RE: **P.Z. 03-2020 Downtown Chesterfield (Wildhorse Village, LP)** An ordinance amending City of Chesterfield Ordinance 3023 to amend the legal description and development criteria for an existing PC&R Planned Commercial and Residence District for a 99.6 acre tract of land located west and southwest of the intersection of U.S. Highway 40/I-64 and Chesterfield Parkway West (18T620185, 18T620206, 18T620053, 18T630272, 18T630195, 18T640248, 18T640260, 18T640271, 18T620174, 18T640183, 18S410240, 18S410206, 18S430259, 18S430282, 18T640336, 17T320158, 18T640237, 18T640259, 18T620064, 17T320169).

Planning Commission Staff Report

Petition: **P.Z. 03-2020 Downtown Chesterfield (Wildhorse Village LP.)**: An ordinance amending City of Chesterfield Ordinance 3023 to amend the legal description and development criteria for an existing PC&R Planned Commercial and Residence District for a 99.6 acre tract of land located west and southwest of the intersection of U.S. Highway 40/I-64 and Chesterfield Parkway West (18T620185, 18T620206, 18T620053, 18T630272, 18T630195, 18T640248, 18T640260, 18T640271, 18T620174, 18T640183, 18S410240, 18S410206, 18S430259, 18S430282, 18T640336, 17T320158, 18T640237

Figure 5: Connectivity Exhibit

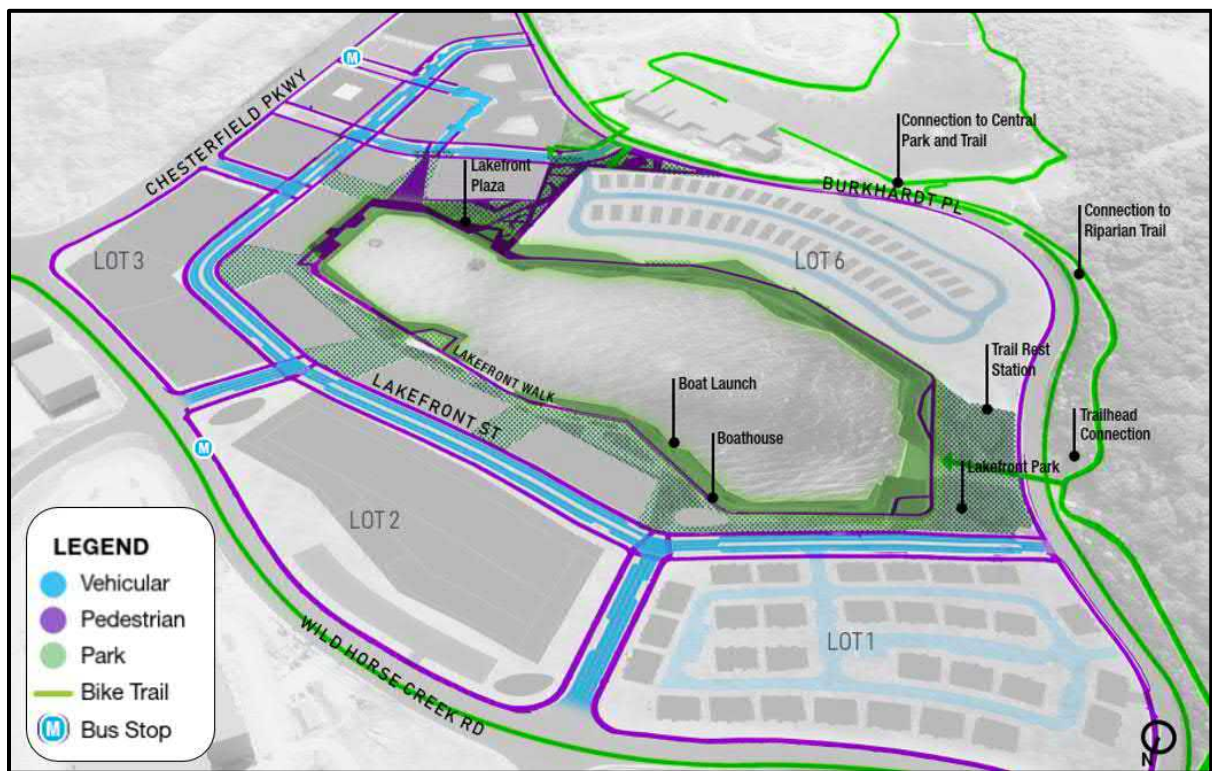
- **Issue:** It was stated that there is a desire to have a less auto-centric request for this zoning petition. It was also stated that there should be an increased focus on creative parking design and pedestrian connectivity. Provide additional information on how all modes of transportation will interact with the site internally and externally.

Response: *Wildhorse Village provides a well-connected pedestrian sidewalk and trail system within the development. This system connects with “all public walks and trails around the perimeter of the site. In addition, vehicular parking, while provided along Lakefront Street, is provided within centralized and convenient parking structures” (See Connectivity Exhibit).*

Figure 6: Ground Floor Activity Exhibit

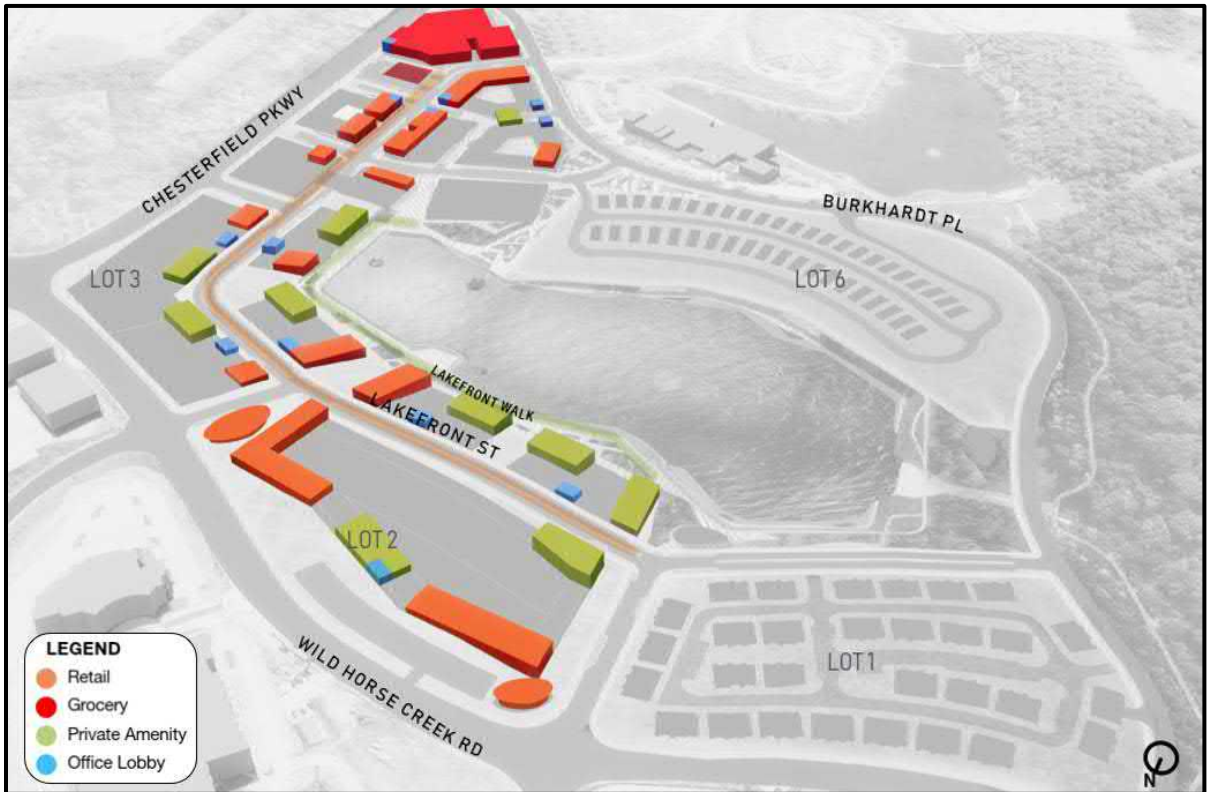
- **Issue:** It was acknowledged by the Planning Commission that they were comfortable with not having first-floor retail on all buildings, but there was a desire to see retail remain on the first floor of some buildings. A statement was made to establish a retail threshold that could be used to understand how much retail would be integrated into the buildings.

- **Issue:** There was concern from residents on removing the requirement for retail commercial on the first floor along the Lake Front Street. Provide information on how first-floor pedestrian activities and architectural design will remain along the Lake Front Street with or without retail.

Response: *The intent is to provide retail within both Category A and B which front Wild Horse Creek Road, Chesterfield Parkway, Lakefront Street, and along Lakefront Walk. (See Ground Floor Activity Exhibit)*

Response: (See Ground Floor Activity Exhibit – Figure 6)

Figure 8: Parking and Parking Garage Exhibit

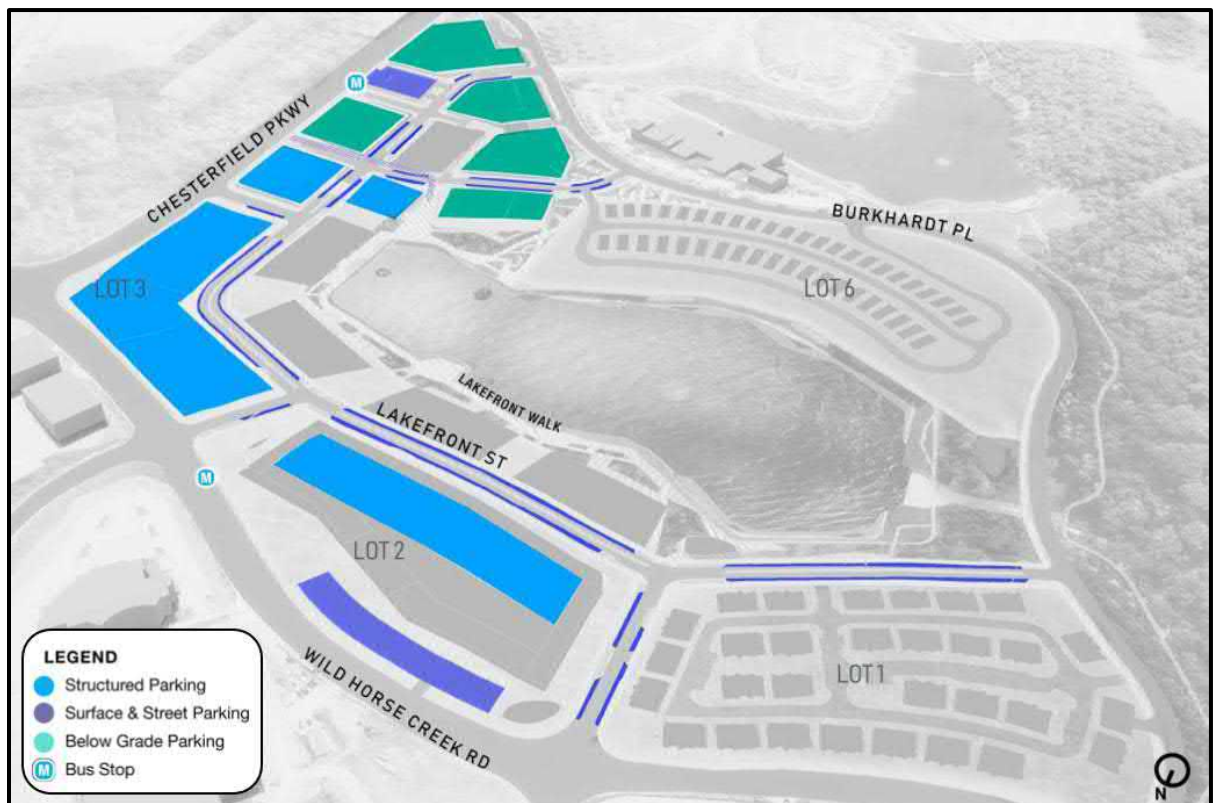
- **Issue:** A statement was made by residents to keep the language in the ordinance in regards to the ground floor retail requirement on parking structures along street frontages. There would be support to remove this requirement on roads if the ordinance contains language that surface parking lots in front of buildings are not permitted and that parking structures were placed behind buildings or that they are designed in such a way that they blend in with the architecture of the area. Provide a response in regards to the utilization of garages and their appearance and function.

Response: *We are proposing to revise the parking structure building function in both Categories A and B to read “Permitted – Ground floor retail commercial, office commercial, or an architectural design that blends into the surrounding area required along street frontage”. (See Parking and Parking Garage Appearance Exhibit)*

Figure 9: Public Amenities Exhibit

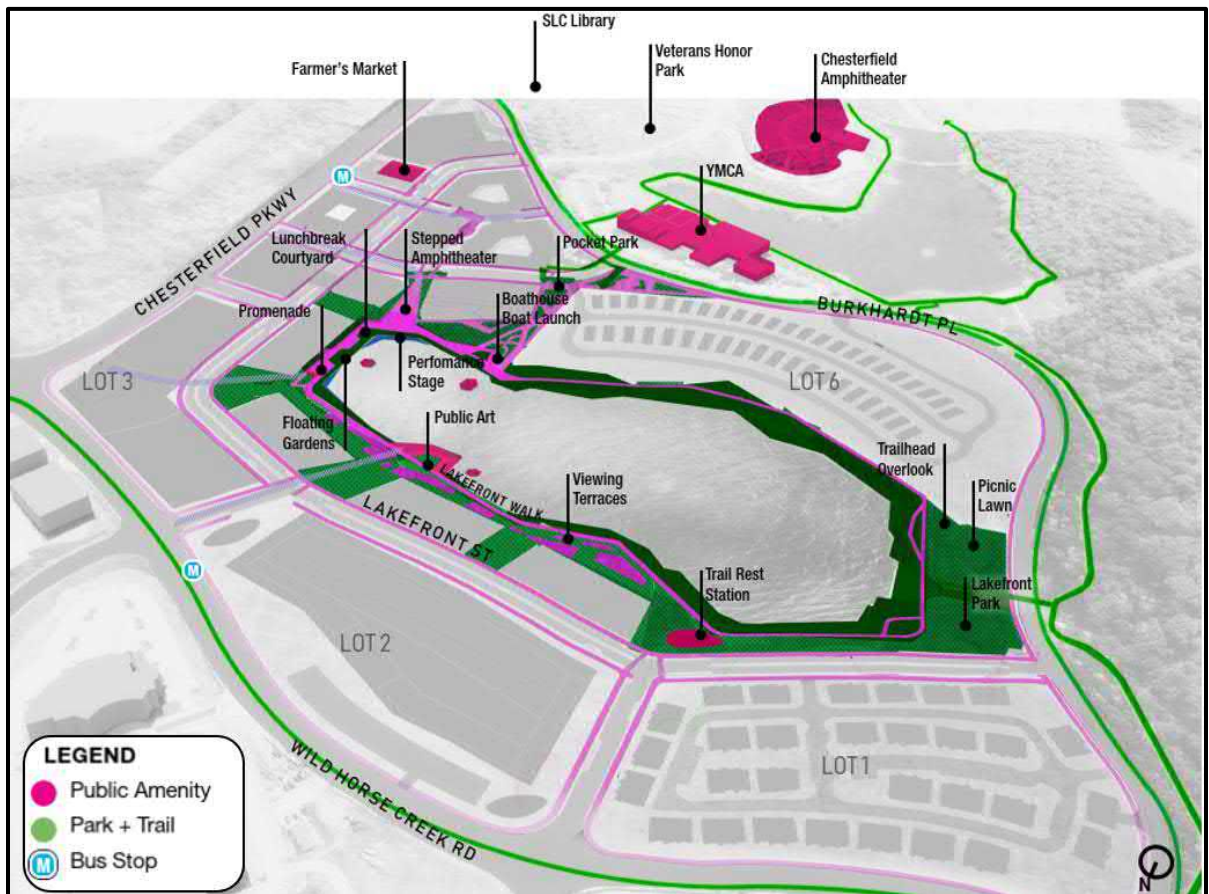
- **Issue:** Amenities are mentioned in the developer's narrative (ie, trails, a small amphitheater or other community gathering spot, boardwalks, trails around the lake, and a boathouse) in which there was a desire by residents to see them written into the ordinance. Provide a statement in regards to this request by the residents.

Response: *Cultural Features: Performance Terrace, Viewing Terraces, Floating Stages & Gardens, and Public Art. Recreational Features: Boathouse, Cycling Trail Rest Station, Trail Overlook, Picnic Lawns, and Pocket Parks. (See Public Amenities Exhibit)*

Figure 9: Lakefront Street Connectivity Exhibit

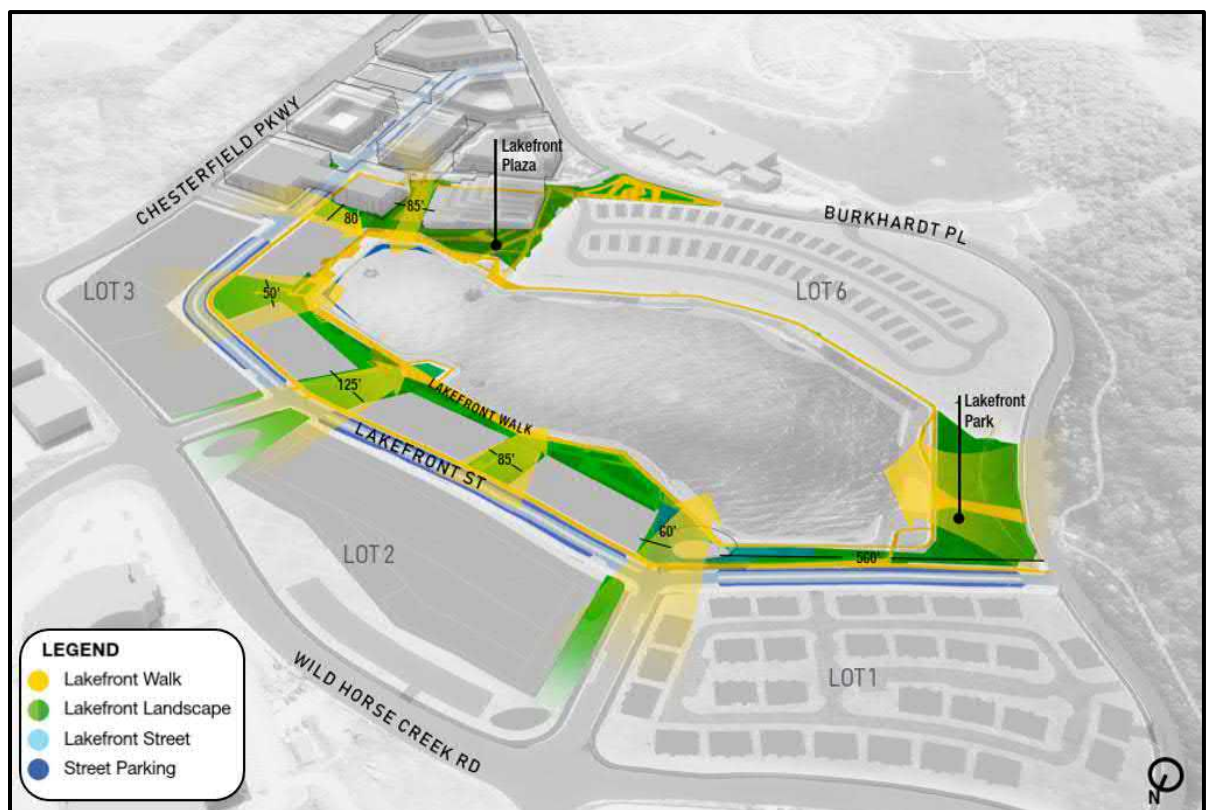
- **Issue:** There was a concern from residents about having buildings on both sides of the Lake Front Street. A desire was stated to minimize the amount of building on the lake side of a Lake Front Street. Provide a further explanation on the interaction of development between the Lake Front Street and the lake.

Response: *The office/mixed use areas will incorporate buildings on both sides of Urban Main Street or “Lakefront Street” with engagement to the lake front trail that encourages pedestrian interaction with the water and amenities being constructed as part of the public realm (See Lakefront Street Connectivity to Lake Exhibit)*

CIRCULATION

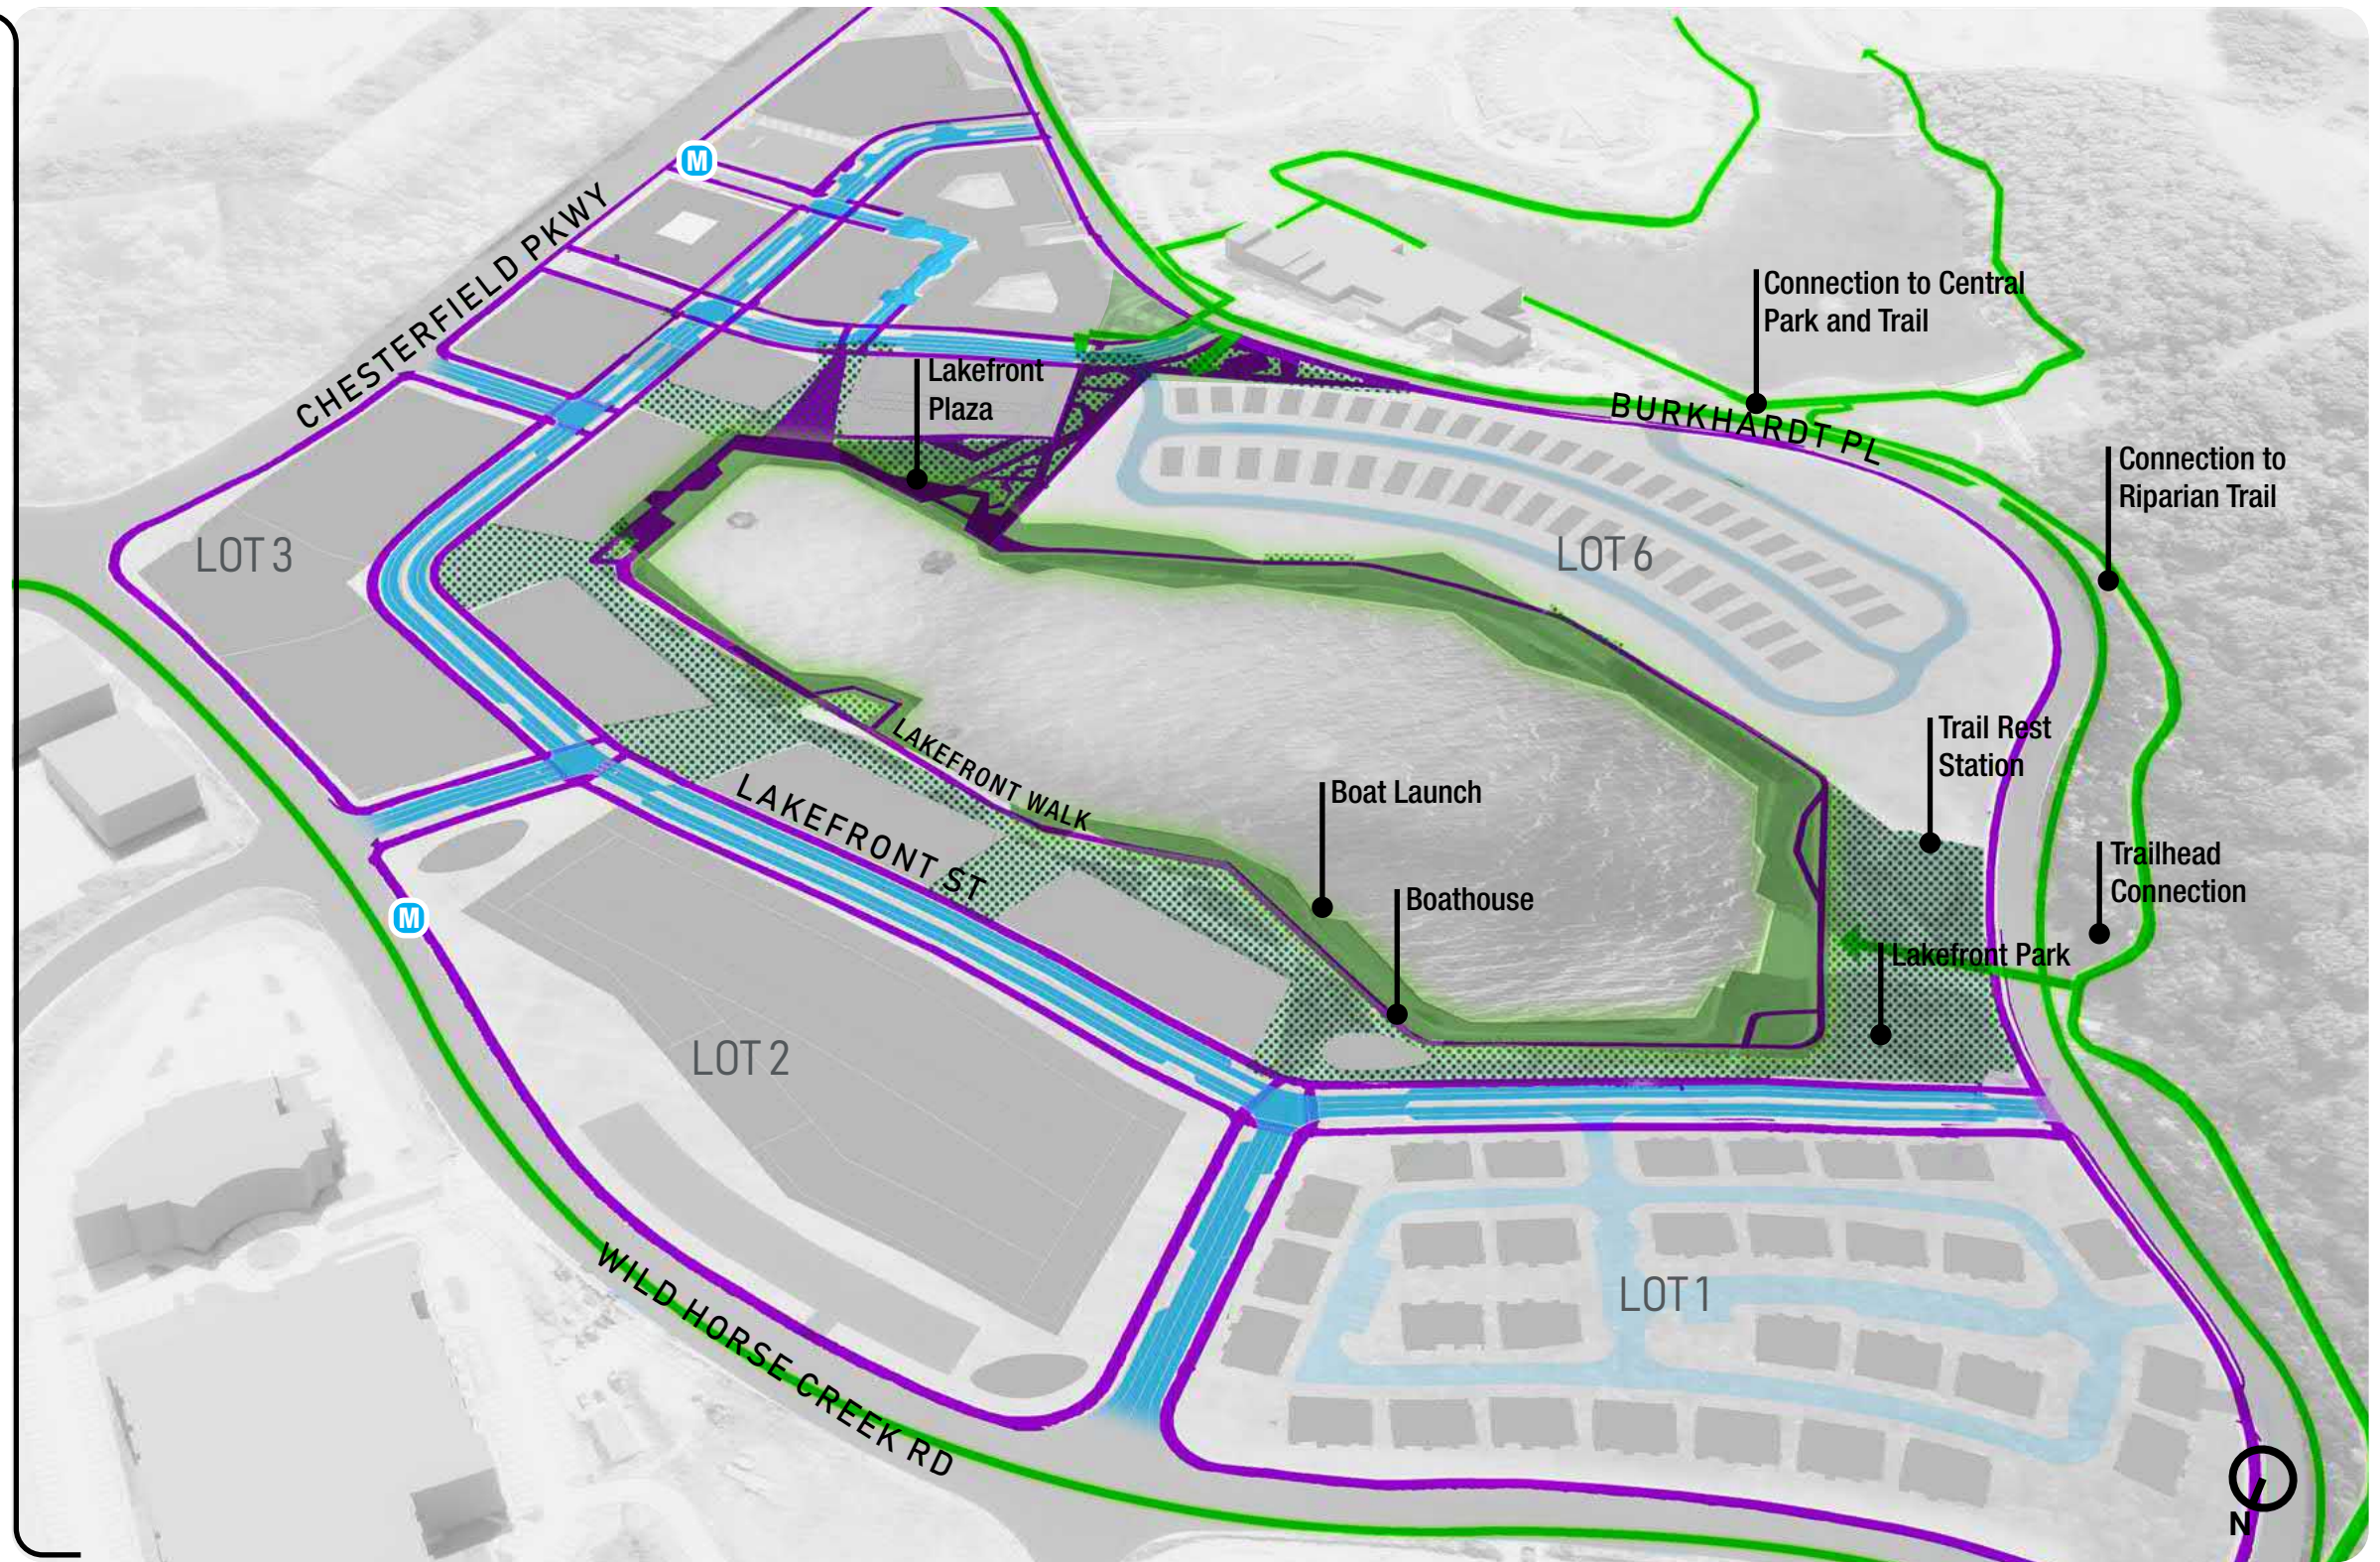
1. It was stated that there is a desire to have a less auto-centric request for this zoning petition. It was also stated that there should be an increased focus on creative parking design and pedestrian connectivity. Provide additional information on how all modes of transportation will interact with the site internally and externally.

Response: Wildhorse Village provides a well-connected pedestrian sidewalk and trail system within the development. This system connects with “all” public walks and trails around the perimeter of the site. In addition, vehicular parking, while provided along Lakefront Street, is provided within centralized and convenient parking structures. (see the Circulation slide in the LJC Exhibit)
